Planning Board
Design Review Meeting

**DESIGN
RECOMMENDATIONS**

21 Crown 40B

September 3, 2015

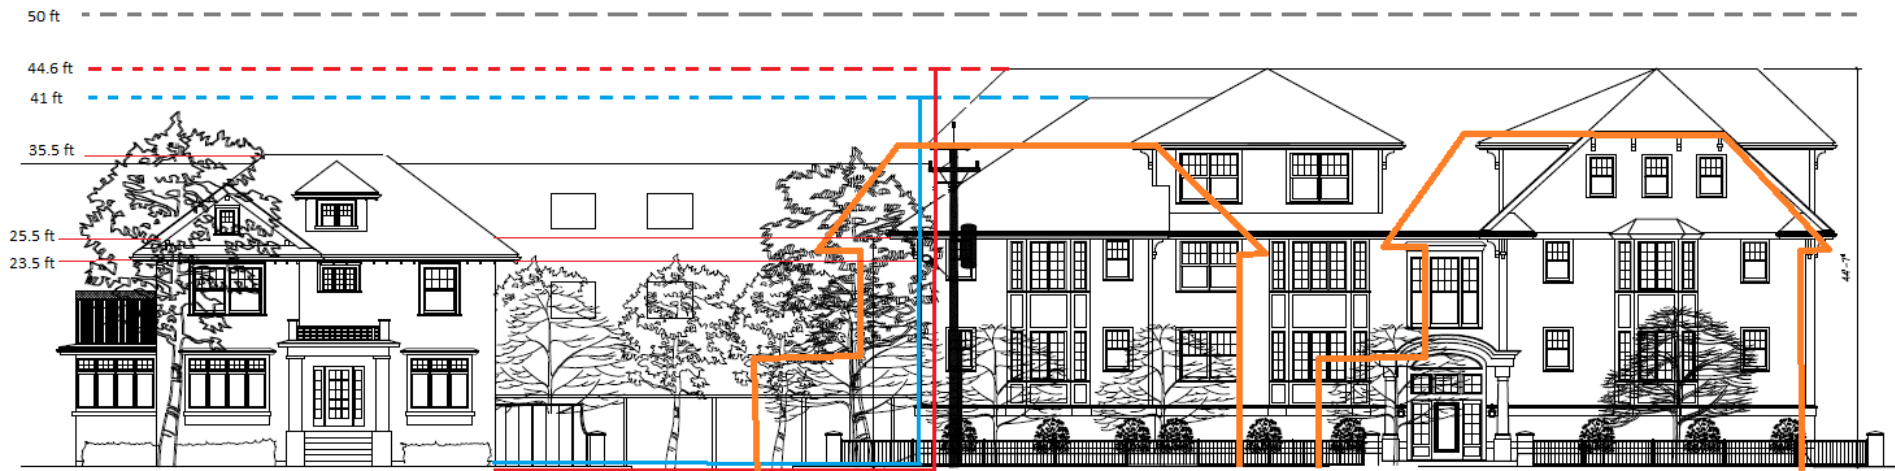
Existing reference points for
visualizing height and setback

Setback Ratios [rise / run] - left side yard

Third Floor Height	41 / 47 = 0.87	Existing 35 / 27 = 1.30
Fourth Floor Height	44.6 / 51 = 0.87	Per Zoning 35 / 7.5 = 4.67

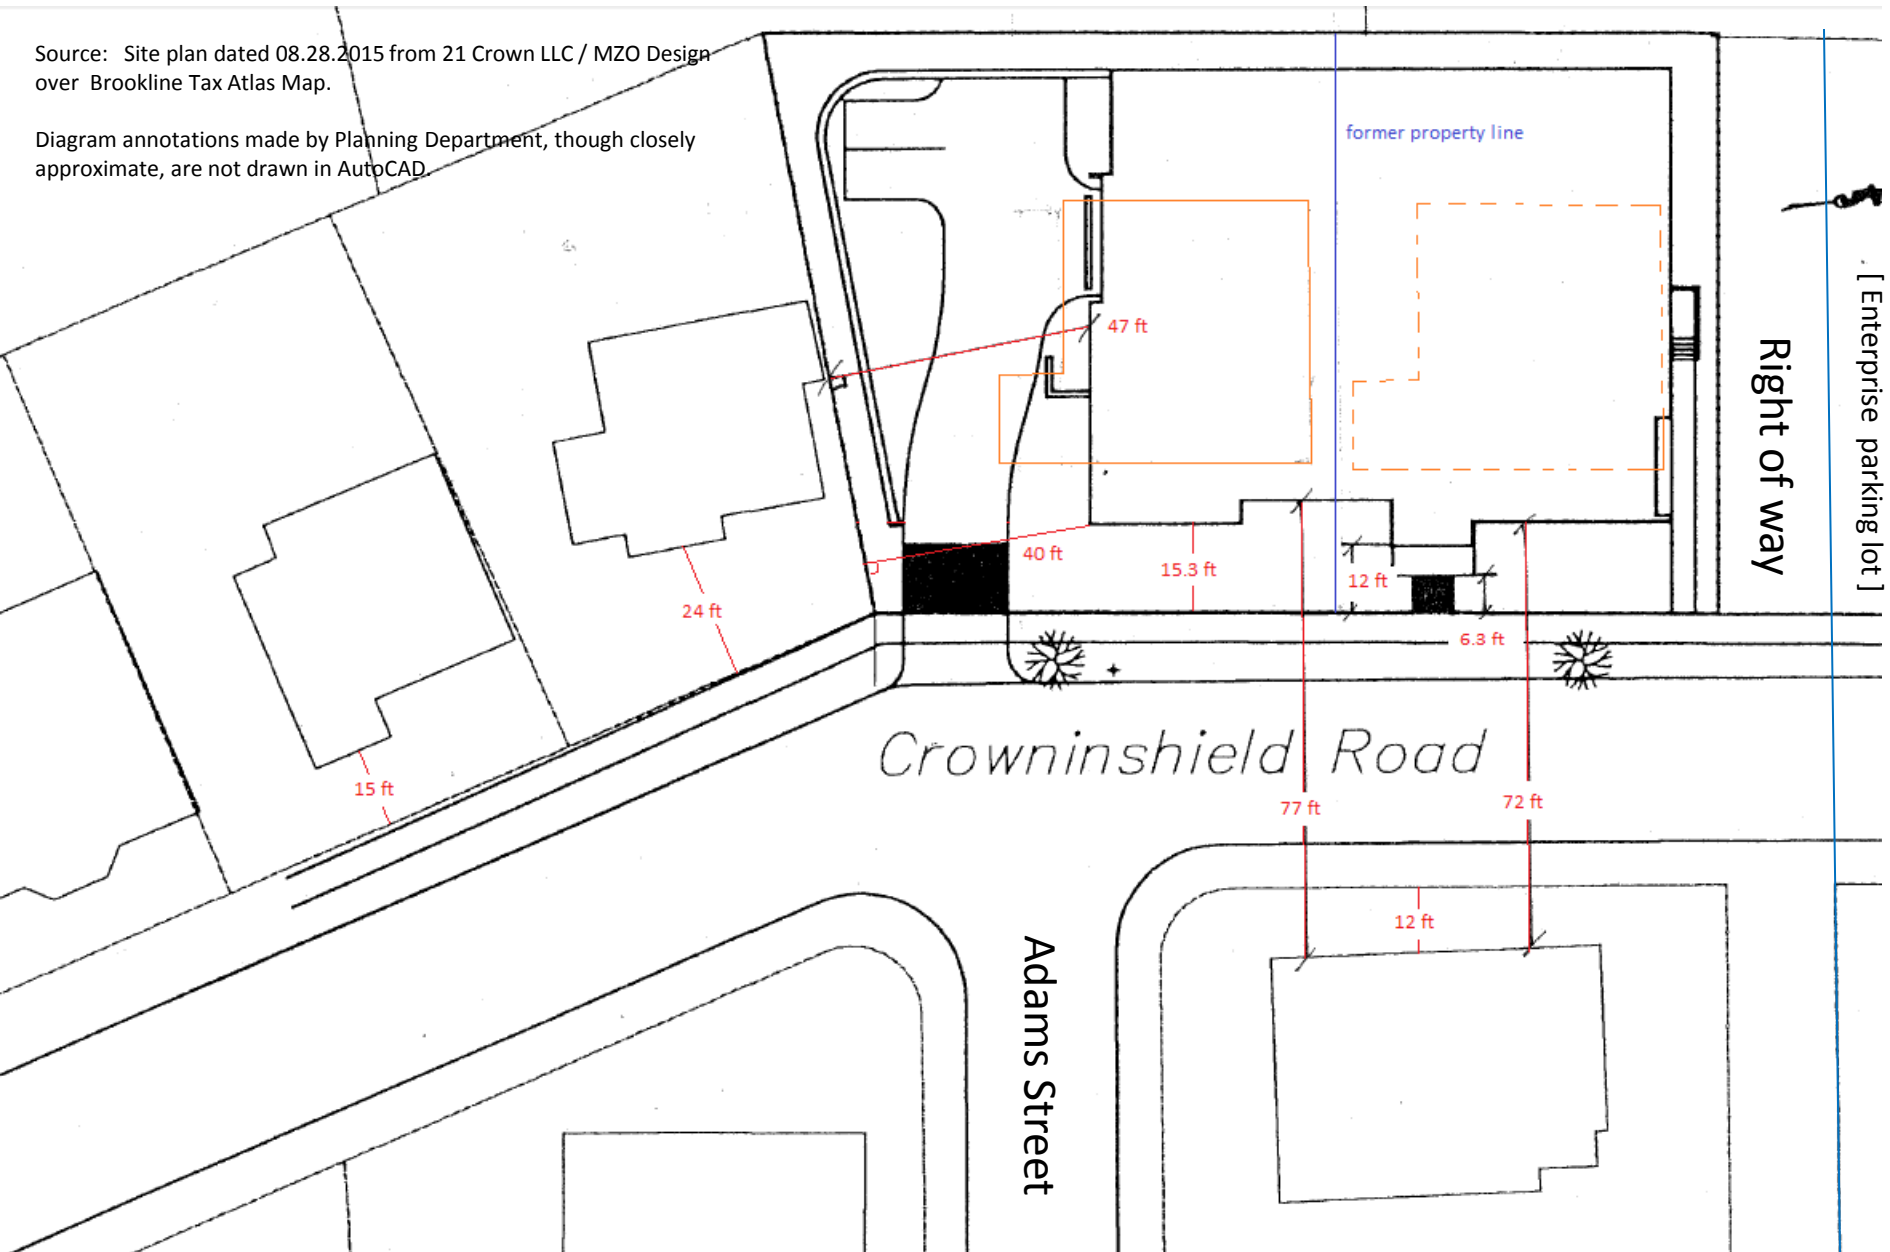
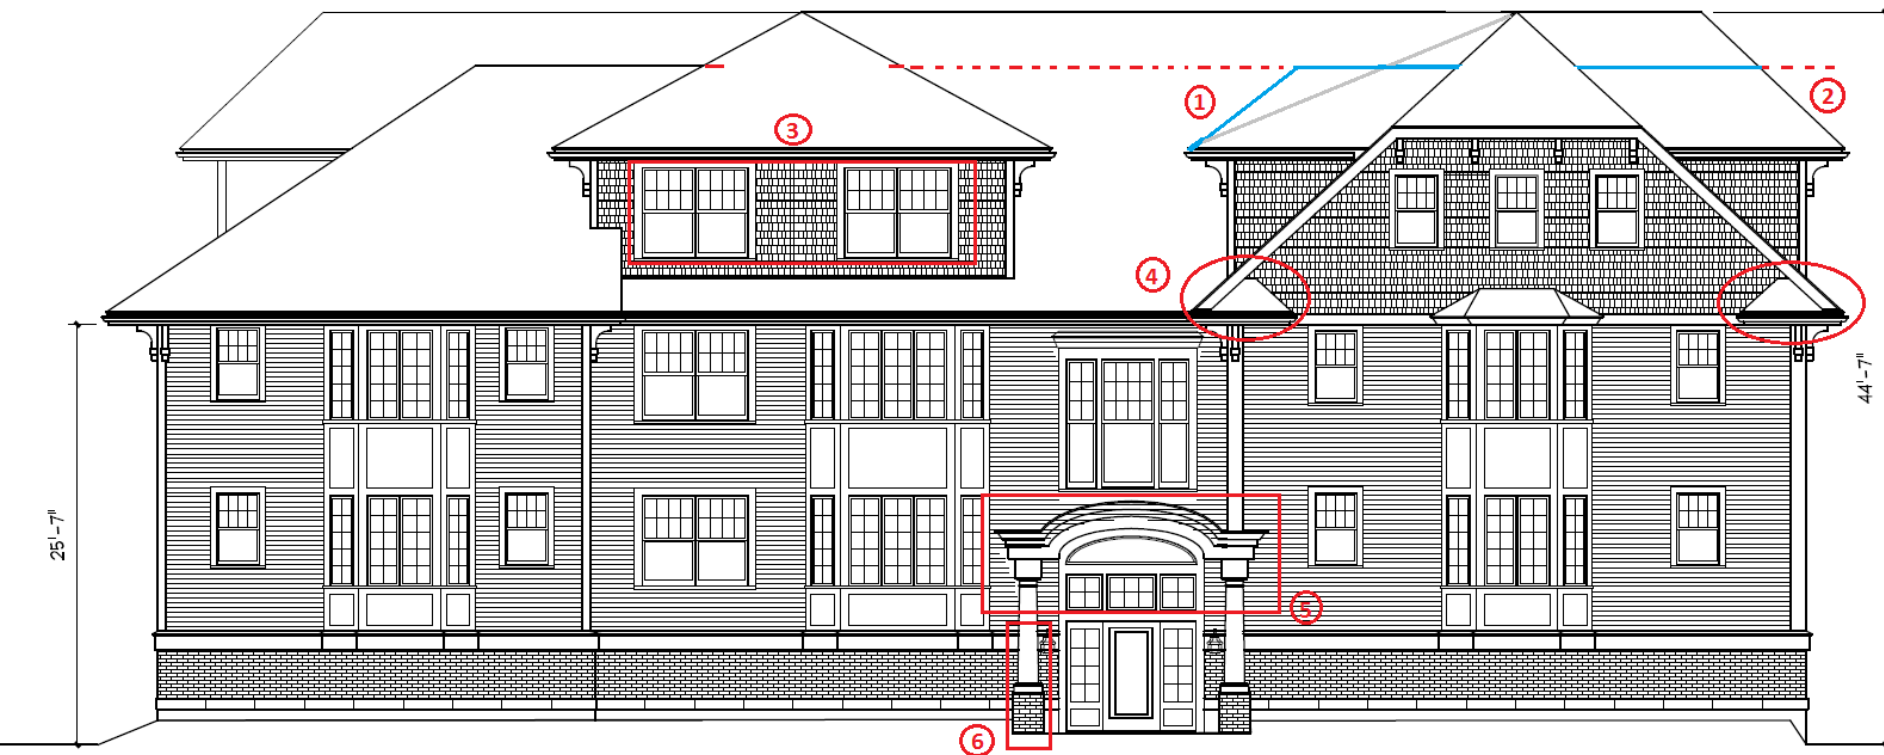
- 1** – Balance gables on each side of jerkinhead by making gables same pitch. Reduce excessive spaces by aligning ridge with third story.
- 2** – Reduce width of gables on right (and left) façade (see separate slides).
- 4** – Reduce slope of eave returns.

- 3** – Dormer has more weight than front entrance. Reduce size of windows to establish better hierarchy. For e.g., use mullions instead of ganging windows; consider 6/1 division of lights instead of 8/1 (typ.).
- 5, 6** – Adjust proportions of portico and piers to establish better hierarchy (see following slides).

Front entrance engages with the bay through the extension of trim and foundation so the two elements appear related, not disconnected or competing for hierarchy. Connecting the portico with the bay also makes this entrance more substantial.

In contrast, if portico were to align with another architectural element, the sunken effect would be improved and entrance would be focal point.

Example of shed roof and eyebrow portico

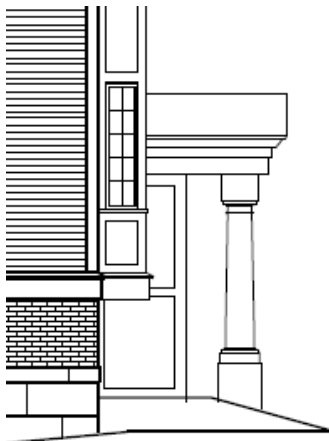
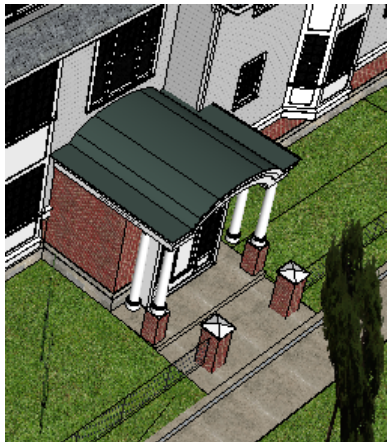
Connection to window above integrates the two elements.

Reduce height portico. Consider a shed roof to improve water runoff, and eyebrow shape that is more gently sloped.

Raise height of piers to align with height of brick foundation.

Portico extends further into front yard to accommodate changes on garage level. A shed roof may soften the effect of the deeper entrance.

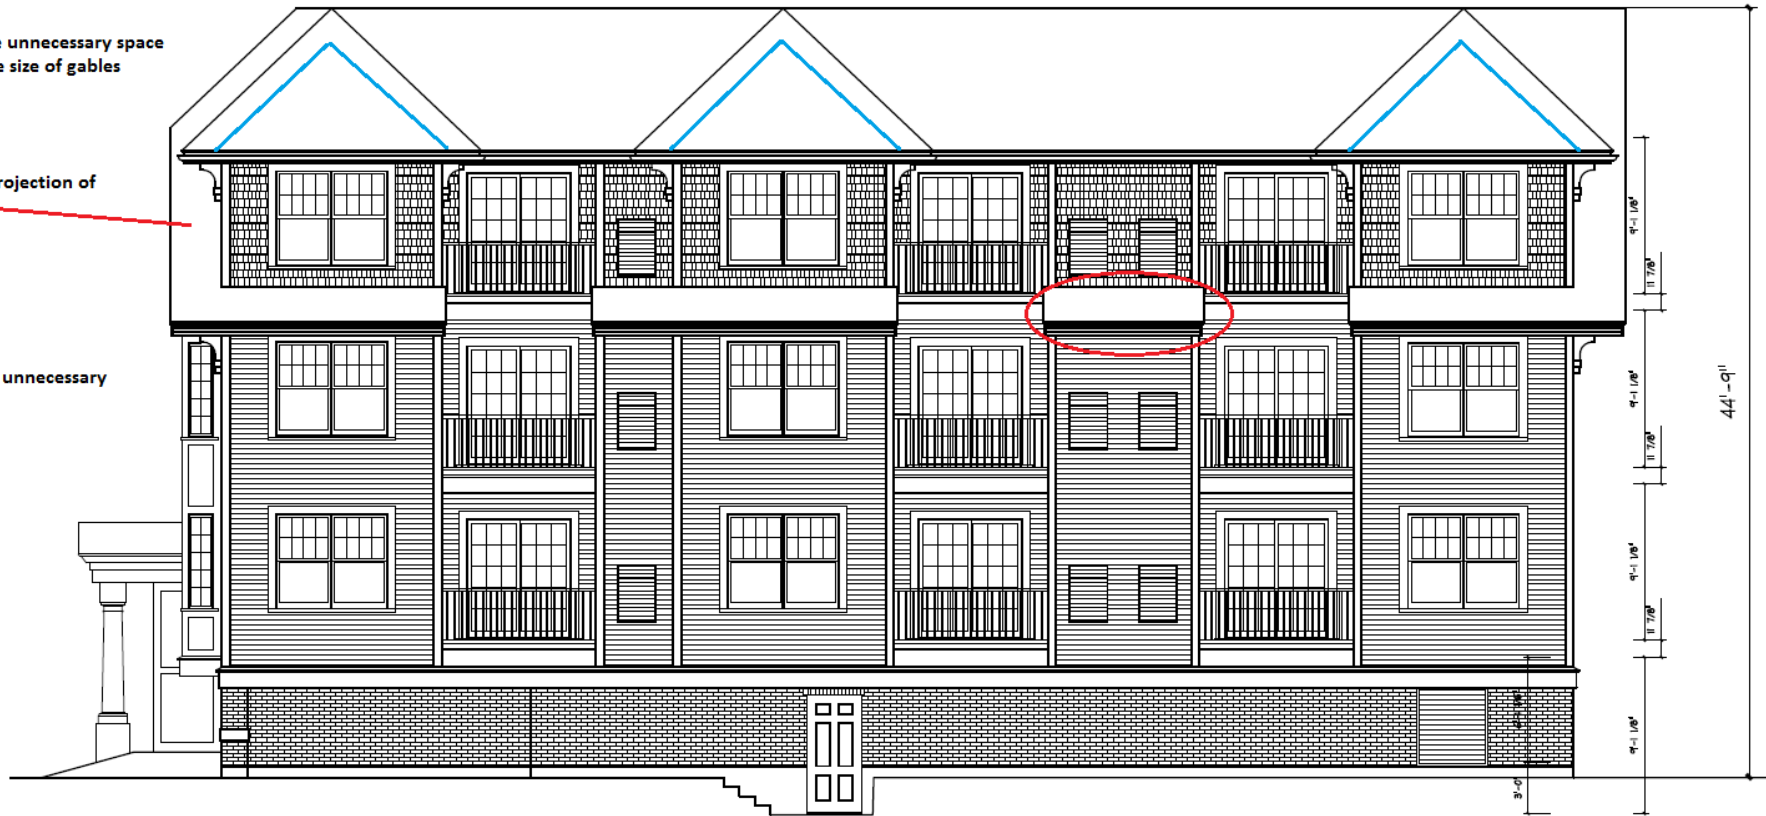
Berm is shown on the
right side.

Eliminate unnecessary space
to reduce size of gables

Reduce projection of
trim

Eliminate unnecessary
trim

- 1 – Eliminate return and connect trim
- 2 – Reduce side of gable
- 3 – Connect trim on third gable

- 4 – Reduce projection of trim
